June 29, 2016

Re: Austin Avenue Bridges at the San Gabriel River Assessment

Figure 5. Strengthening Options for a Steel Bottom Flange:
(a) and (b) horizontal plates, (c) two vertical plates, (d) prestress tendons

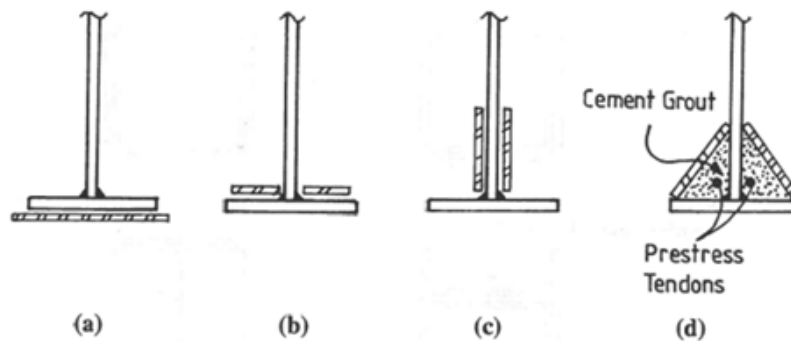
1. Deck Replacement: Partially replacing the existing non-composite deck with a composite deck (i.e.; Spans 2-4 South Bridge and Spans 4-6 North Bridge) will increase the superstructure's load rating, Condition Rating and Service Life. This would require a phased construction which will impact traffic significantly during construction.
2. Strengthen Critical Section: An alternative option with minimal traffic impact is strengthening the critical section (i.e.; Span 3 South Bridge and Span 5 North Bridge) by modifying the load path or by adding material. This can be achieved with the addition of plates or prestress tendons to the steel beams (See Figure 5).

Option 1	Option 2*
Inventory Rating	HS 29.6	HS 20.6
Operating Rating	HS 49.4	HS 34.3

*Assumes 1/2" horizontal plates are added to critical section
